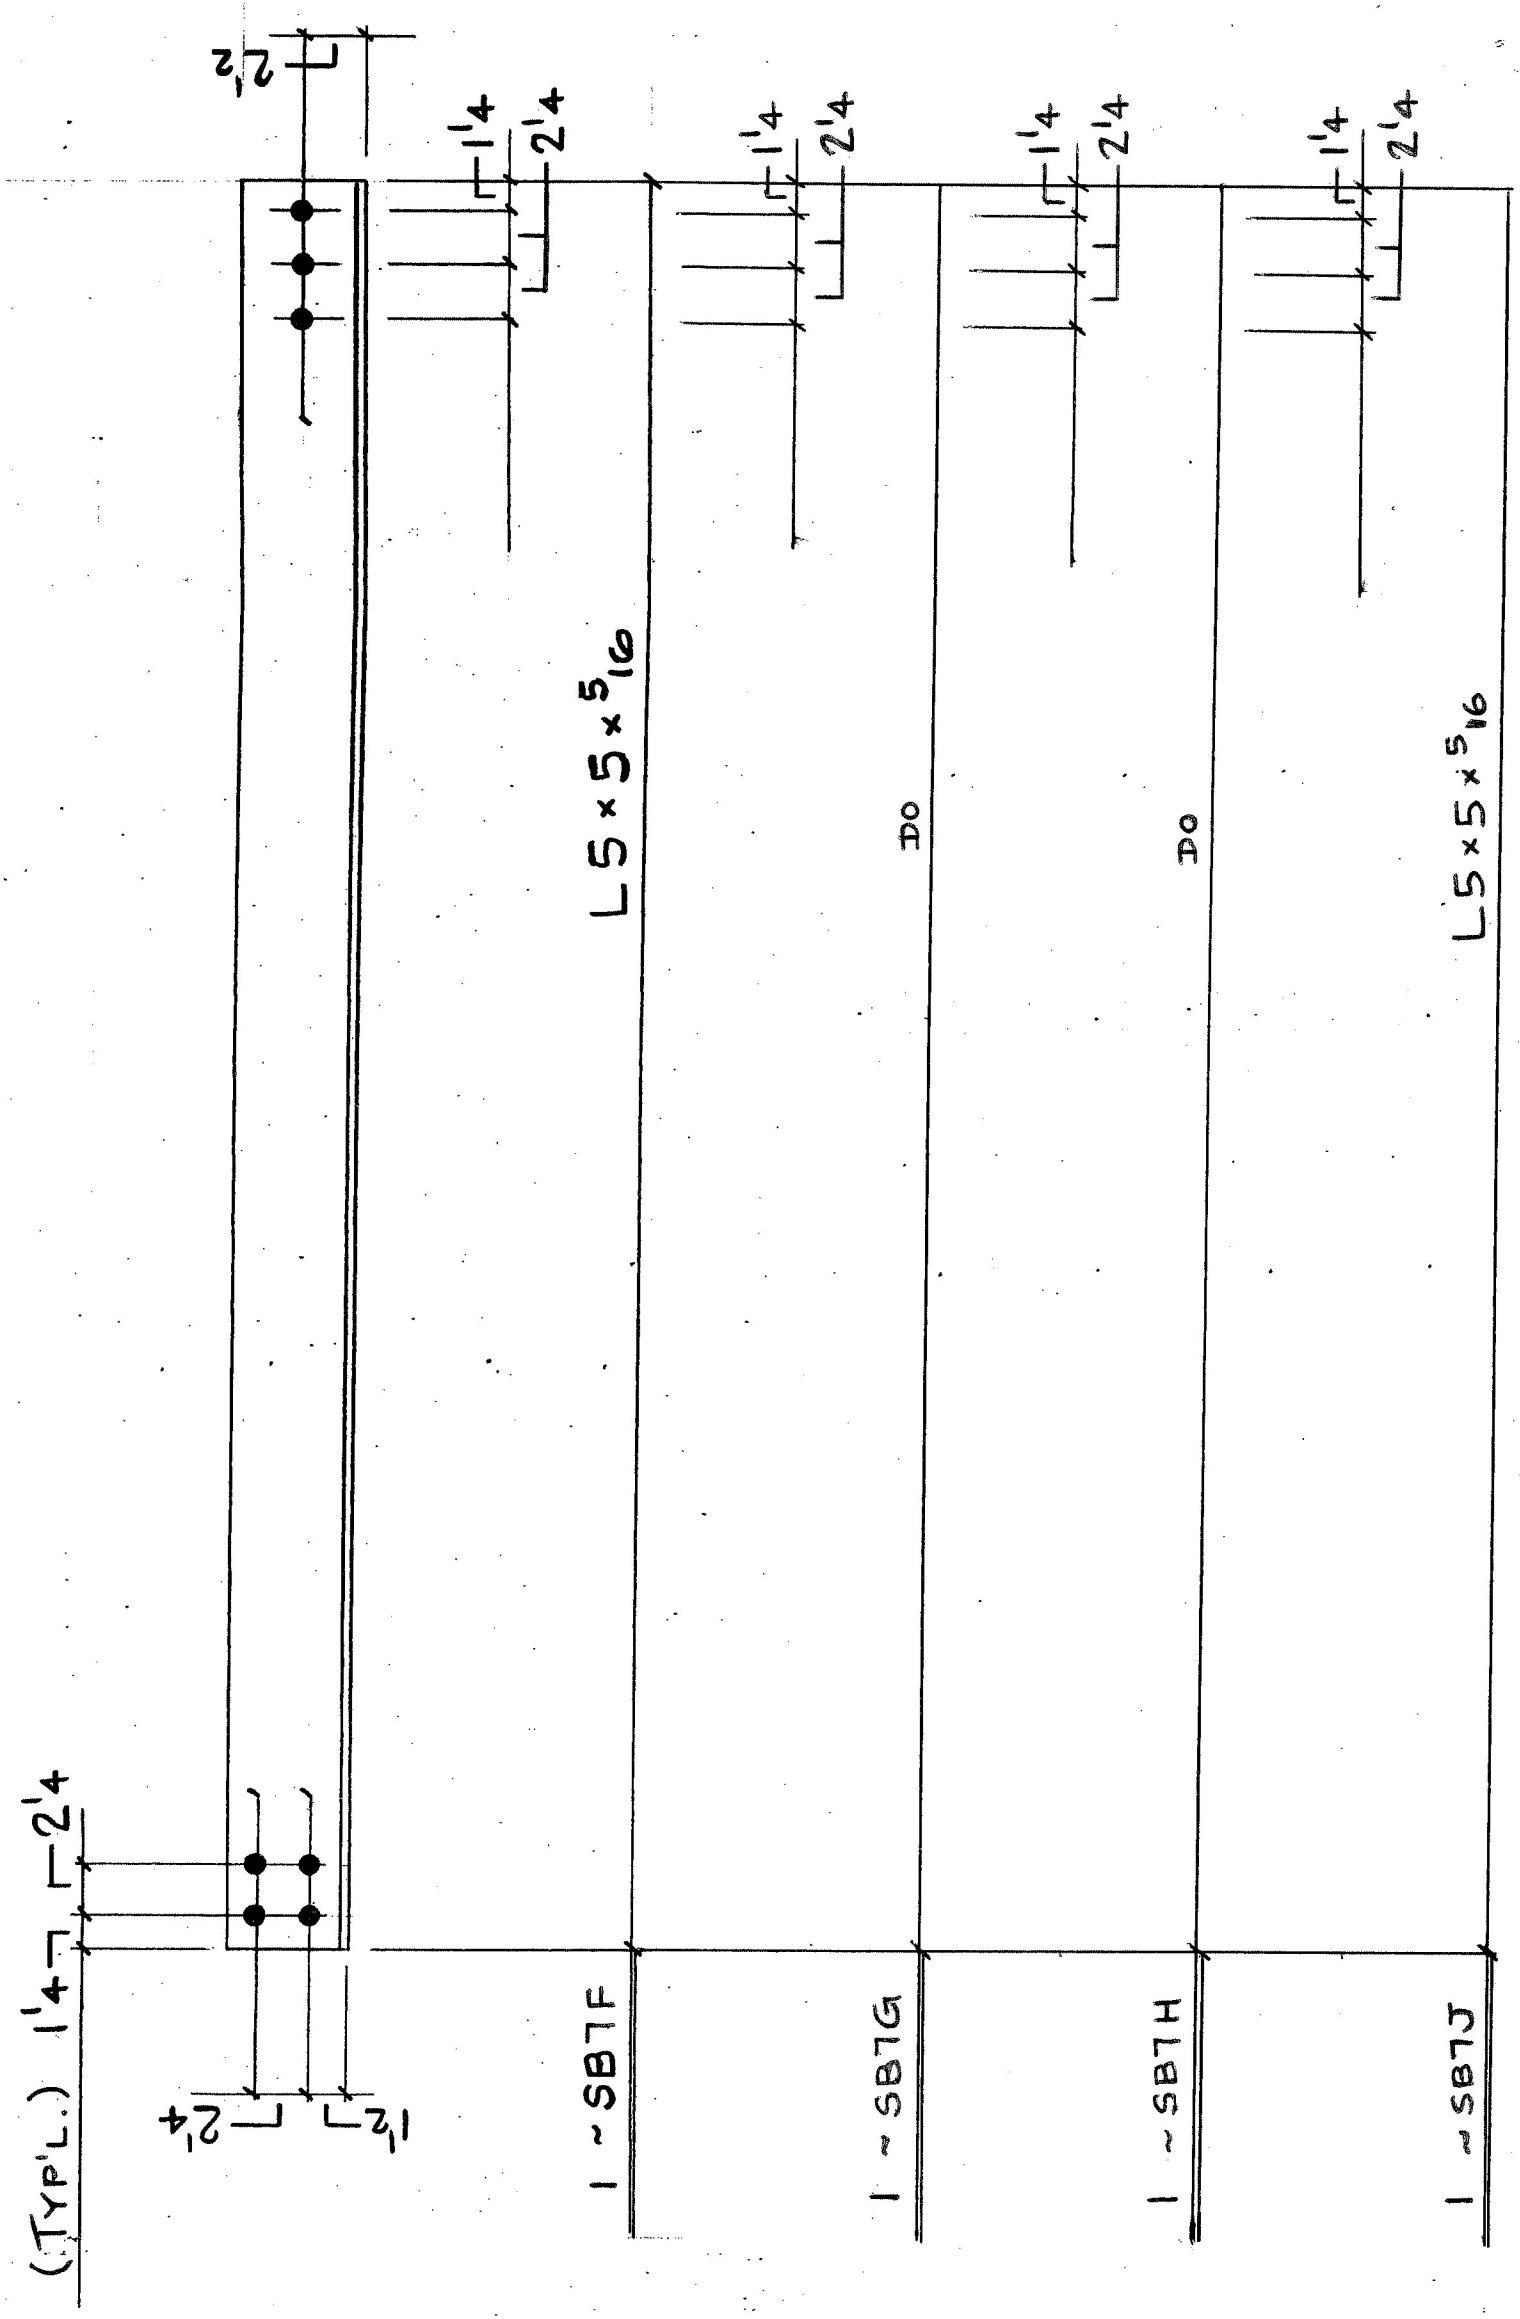
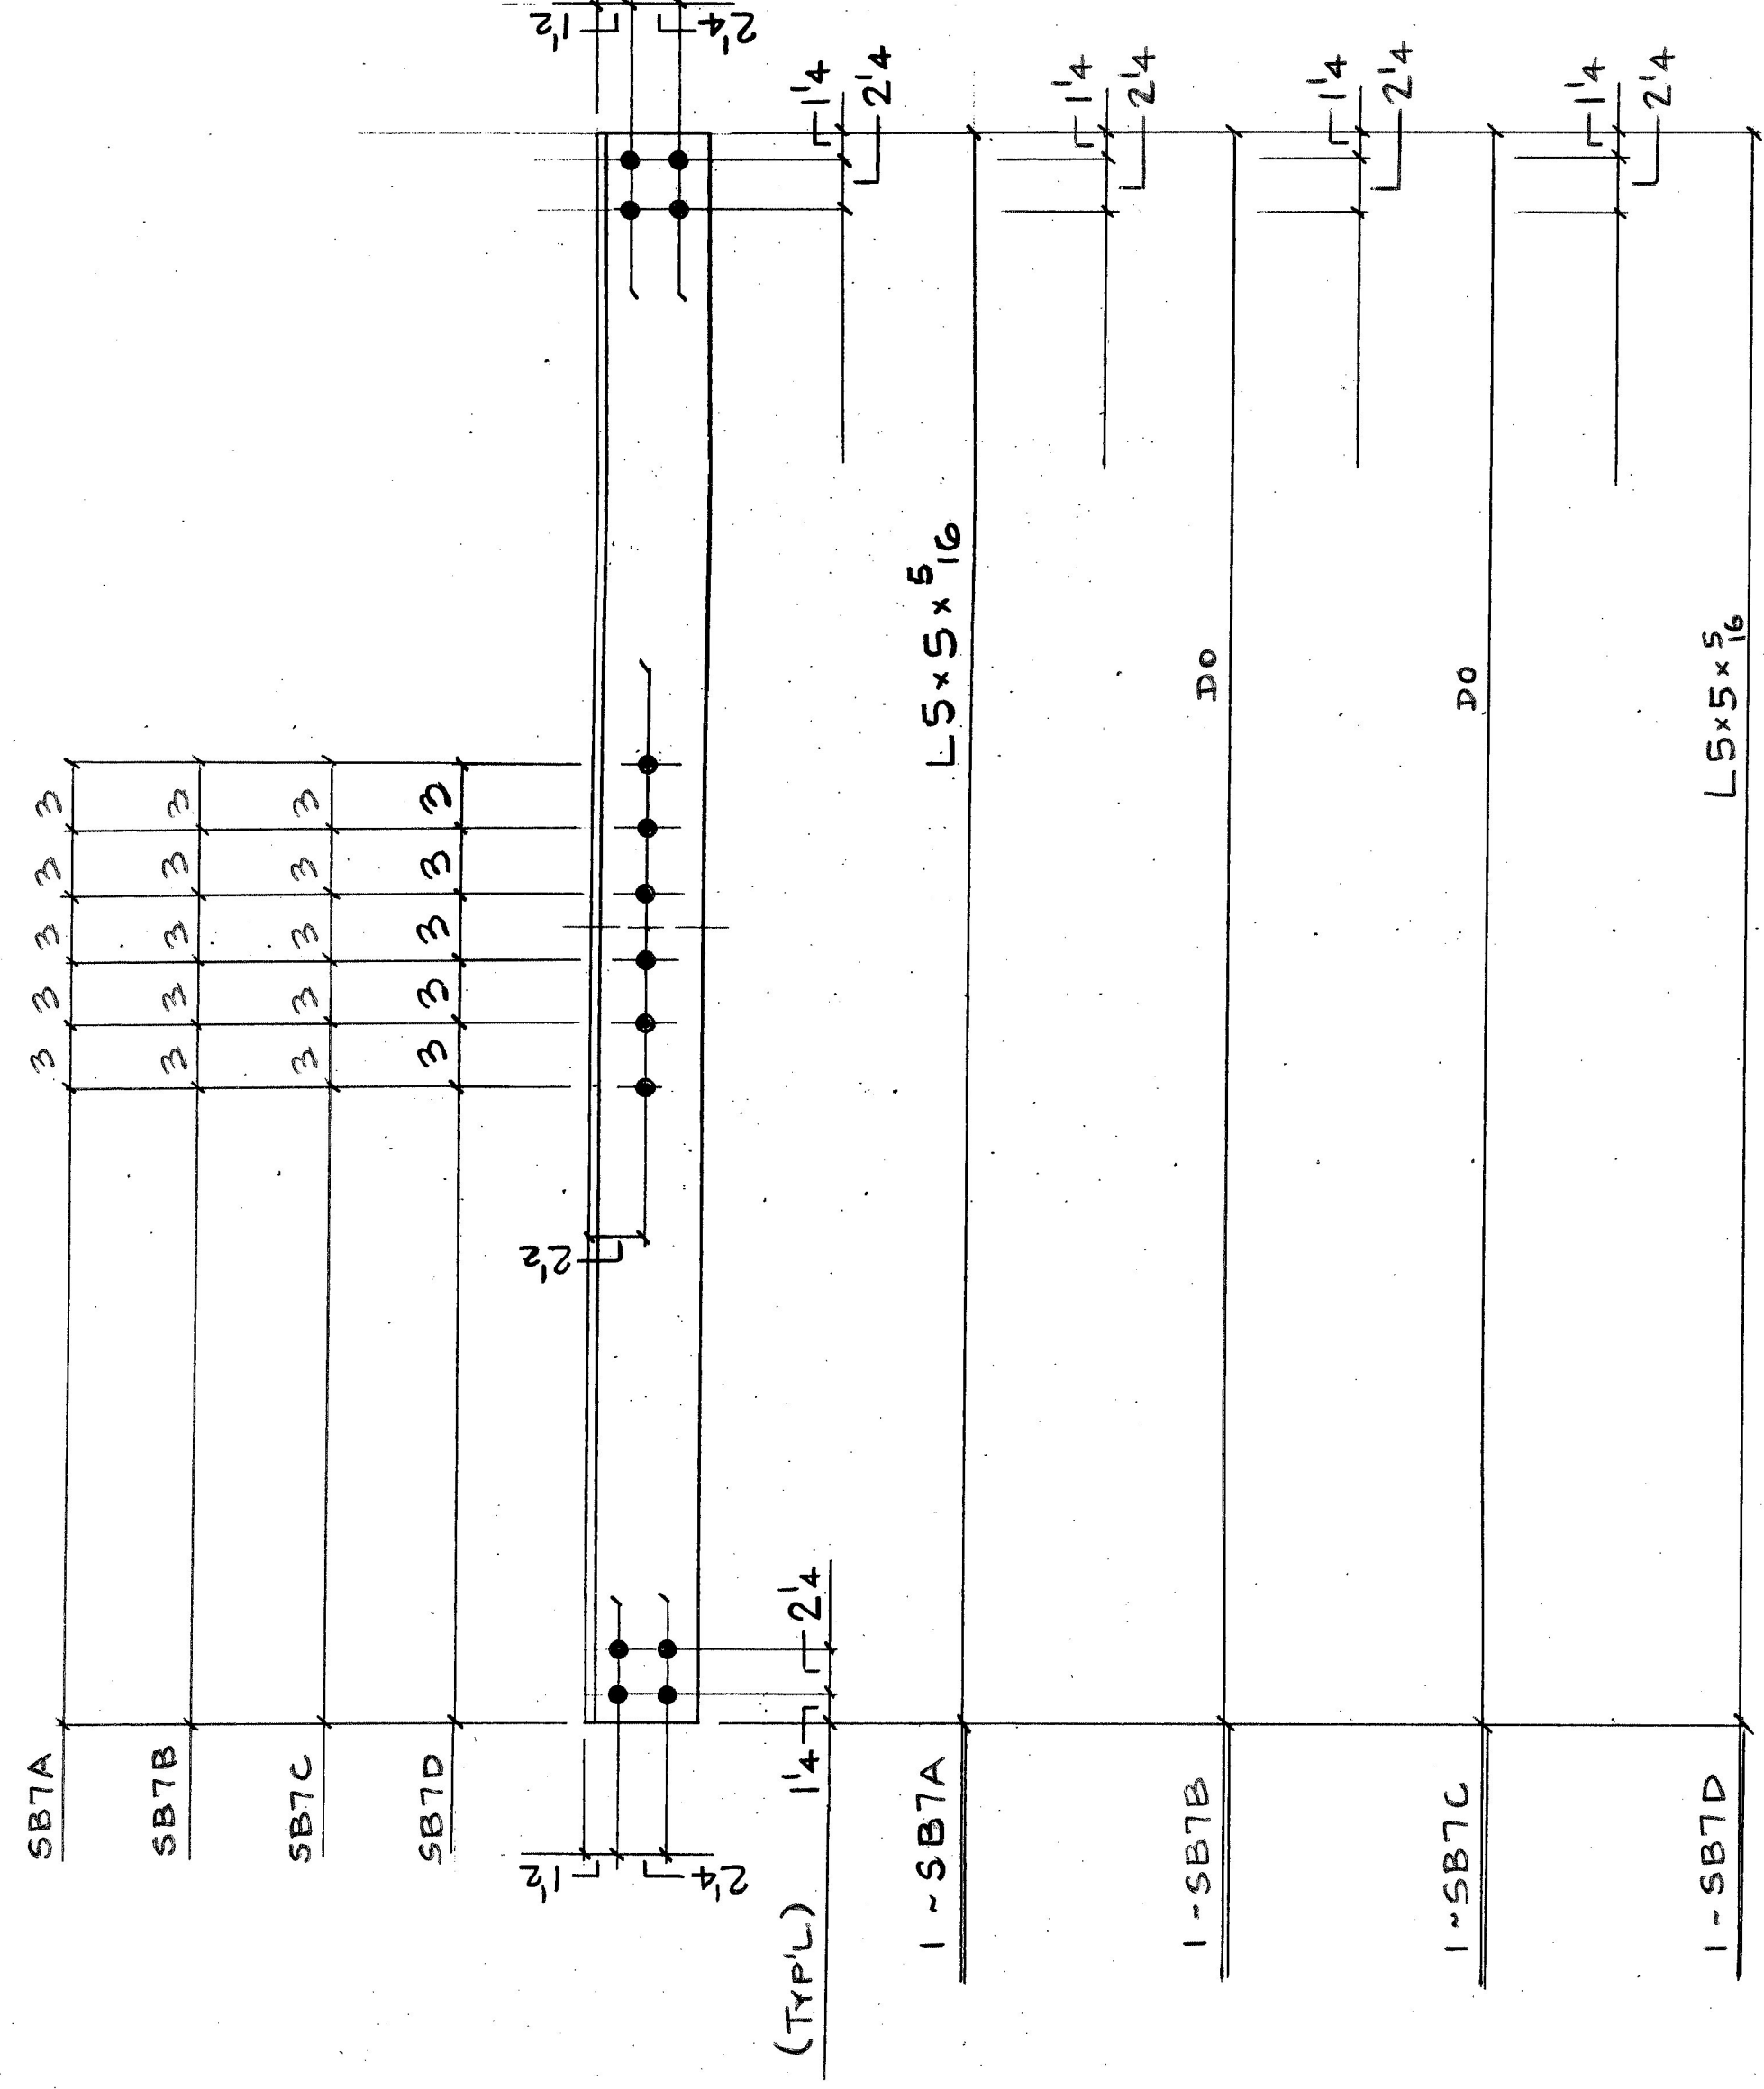
The replacement of members EPI, U1-U2, U2-U1', and EPI' necessitates different details than shown on this sheet. See Sheets 10-13 (1/4-4/4) for modifications.

FIELD LOCATE MISSING HOLE DIMENSIONS HOLES TO BE SHOP DRILLED. FIELD TO SUPPLY CUT LENGTHS FOR ANGLES. BAYS DIFFER SLIGHTLY

Note - The original shipment of pieces will not include the angles before the pieces are assembled, without these pieces, angles. Deck bracing connection plates and dimensions shall be angles.
